# MONA OFFSHORE WIND PROJECT

## Response to Written Representations

Document Reference: MOCNS-J3303-RPS-10288

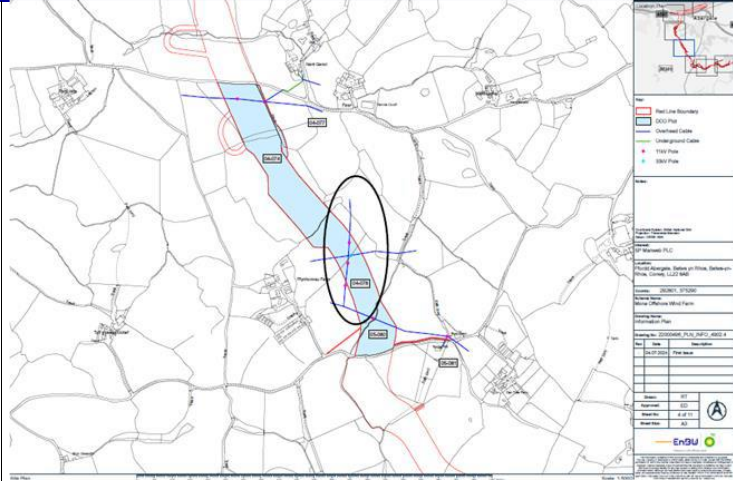
| Reference         | Written Representation Comment   | Applicant's response   |
|-------------------|--|--|
| <p>REP1-077.7</p> | <p>Furthermore, reference to the Works Plan (Doc no. AS – 003) shows there to be proposed planting and environmental works under SP Manweb apparatus.</p> <p>The submitted Crossings Schedule (Document APP -083) lists various crossing points and refers to where trench and trenchless crossings are proposed.</p> <p>SPEN acknowledges that the draft DCO (Document AS-010) allows for diversions where necessary within the order limits and the protective provisions in Schedule 2 Part 4 require agreement with SPEN on works within 15m of SPEN assets.</p> | <p>The Works Plan - onshore (AS-003) shows the areas in which landscaping, ecological and environmental work may take place, in particular at the onshore substation site. The undertaker will also have general powers to undertake planting works anywhere within the Order limits.</p> <p>The final details for landscaping and ecology works will be agreed through the final landscape and ecology management plan which will be submitted to and approved by the relevant planning authority in accordance with requirements 8 and 12 of the draft development consent order (C1 F04). The final landscape and ecology management plan will reflect the detailed design of the onshore works and any necessary considerations for statutory undertaker apparatus.</p> <p>The Onshore Crossing Schedule (F5.4.3 F01_F02) identifies obstacles to be crossed, including identified SP Manweb assets, and notes how these are proposed to be crossed. There is also an indication of whether those crossings will be trenched, trenchless or retain flexibility to cross with either technique and detailed design to be undertaken closer to the time of construction.</p> <p>The Order limits include appropriate flexibility to allow for micro-siting of the onshore cable installation and to ensure that SP Manweb's apparatus is appropriately accounted for. Further to this, the DCO allows for removal and reinstatement of SPEN assets if required.</p> <p>The Protective Provisions included in Part 4 of Schedule 10 of the draft development consent order (C1 F04) provide SP Manweb with adequate protections in relation to works within the vicinity of the SP Manweb apparatus. Paragraph 7 of the Protective Provisions already provides that detailed plans for these works must be submitted to and approved by SP Manweb prior to relevant works commencing. This approval may be made subject to reasonable conditions for the protection of SP Manweb apparatus including the removal and relocation of apparatus if required.</p> |

REP1-077.12

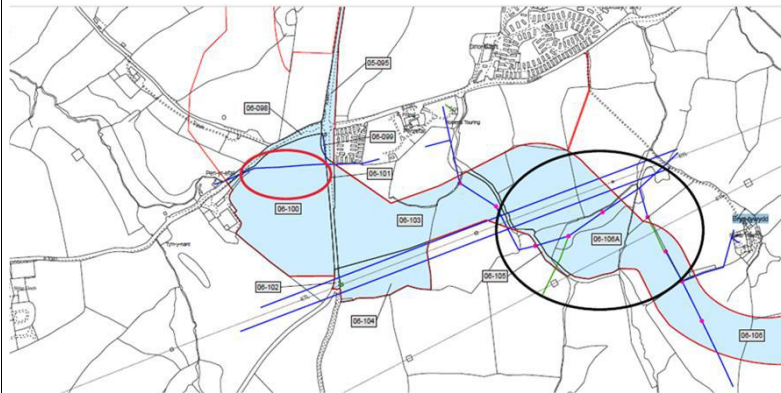
Bryn-tywydd  
At this location, there are 11kV poles the movement of which is restricted by the 132kV overhead line (the red circled area highlights poles not shown).

The Applicant notes the location of the apparatus on the plan.  
This area is identified in the Environmental Statement Volume 5, Annex 4.3: Onshore Crossing Schedule (REP1-007) and lists the proposed crossing technique (Mapping ID 87).

REP1-077.14

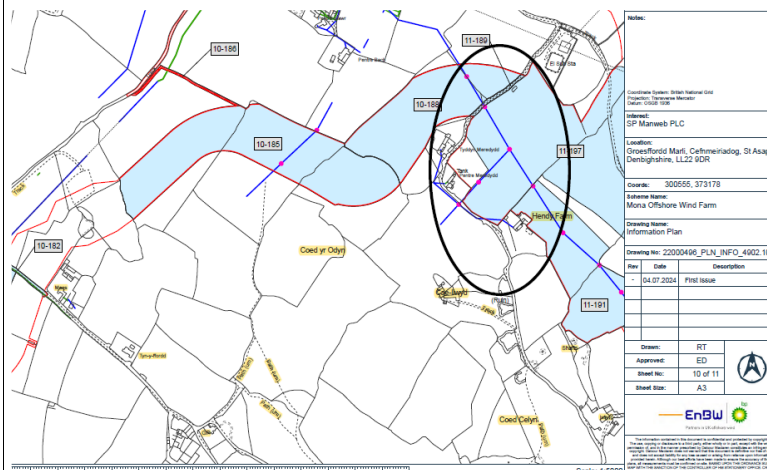
**Hendy Farm**  
 At this location, there are a number of wood poles to avoid and in addition, the area leading into the substation is a proposed landscaping area, the design of which needs to be considered in detail as some planting is not compatible with the SP Manweb apparatus.

The Applicant notes the location of the apparatus on the plan.  
 This area is identified in the Environmental Statement Volume 5, Annex 4.3: Onshore Crossing Schedule (REP1-007) and lists the proposed crossing technique (Mapping ID 254).
